CITY PLANNING DEPARTMENT

Memorandum – Unified Development Review

To: City Plan Commission
From: Brianna L. Valcourt, M.Arch; Senior Planner
Date: August 18, 2026
RE: “Sinapi-Hague Property” – Minor Subdivision with Zoning Relief

PROPOSED CONDITIONS: SITE PLAN

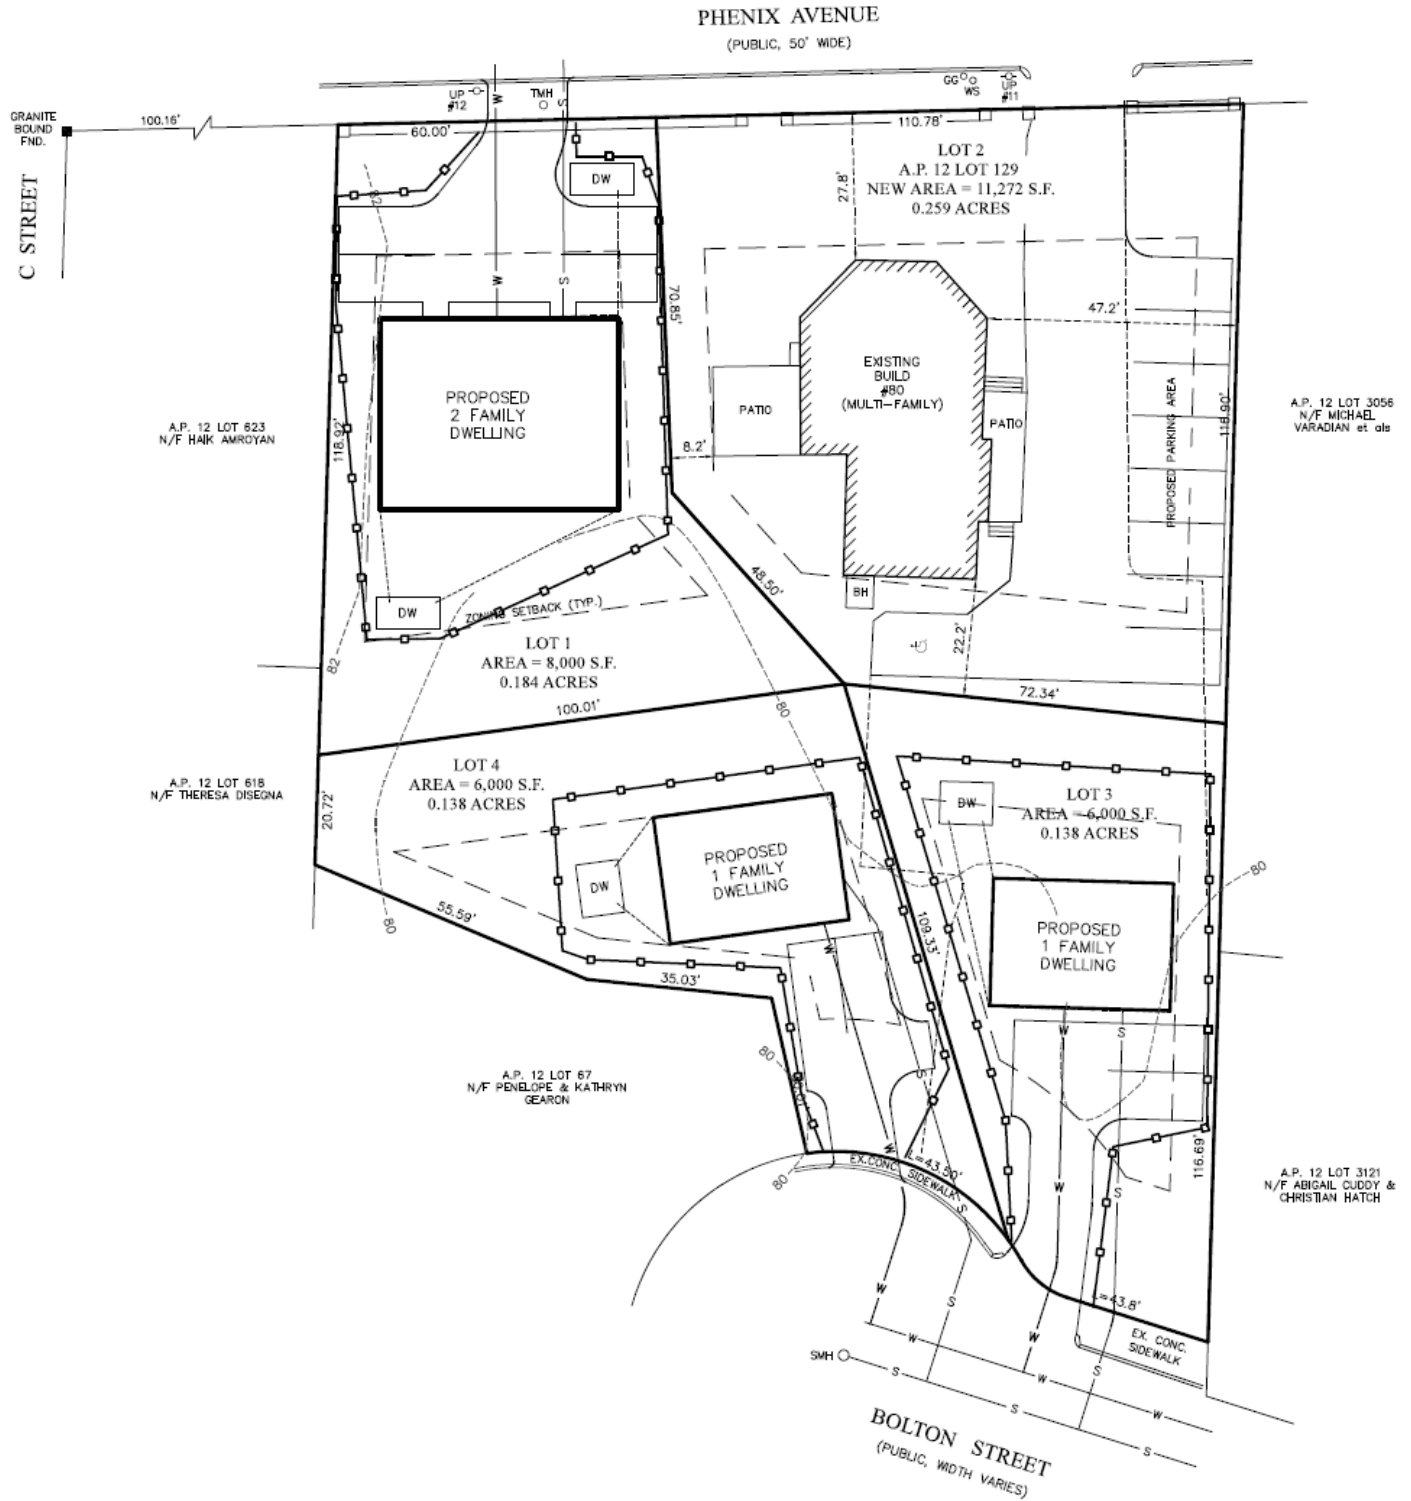
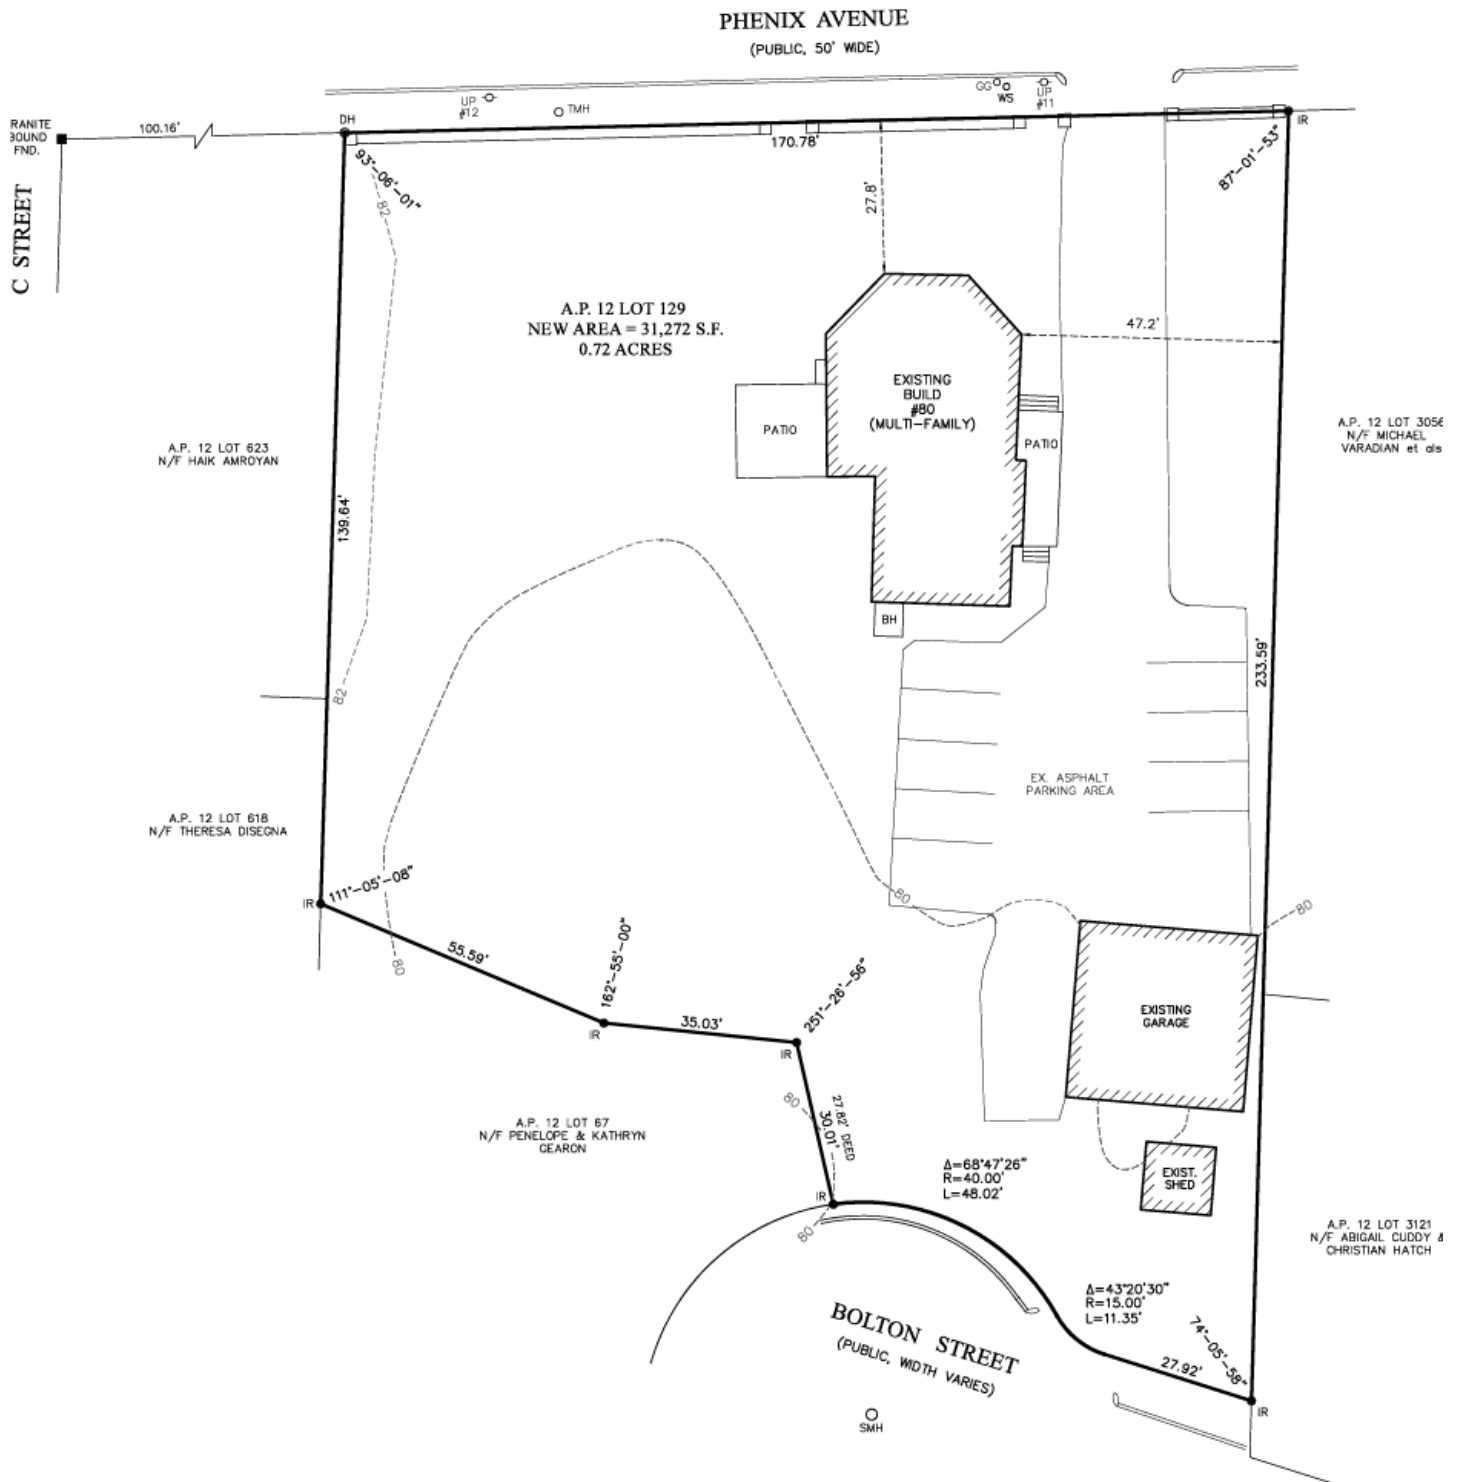
- Staff recommend a condition for the site plan to depict measurements of all curb openings and parking spaces as well as the height of the wall along Phenix Avenue. If the wall exceeds 3 ½ feet in height, demolition would be required within 10 feet of the edge of the proposed driveway on Lot 1. The existing driveway on Lot 2 shall be brought into conformance with the same zoning standard, §17.20.100, to the satisfaction of the Zoning Official.

1. The location and design of stormwater BMP and associated drainage calculations for Lot 2 shall be provided at Final Plan.
2. Dimensions for all driveways, curb openings, and parking areas shall be depicted on the Record Plan.
3. The height of the wall along Phenix Avenue shall be provided at Final Plan. If the wall exceeds the height requirements of Section 17.20.100, proposed Lots 1 and 2 shall be brought into conformance with said requirement, except that the gate west of the driveway of proposed Lot 2 may remain as is. The wall east of the driveway on Lot 2 shall be brought into conformance with the Zoning Ordinance prior to recording of the Final Plan.
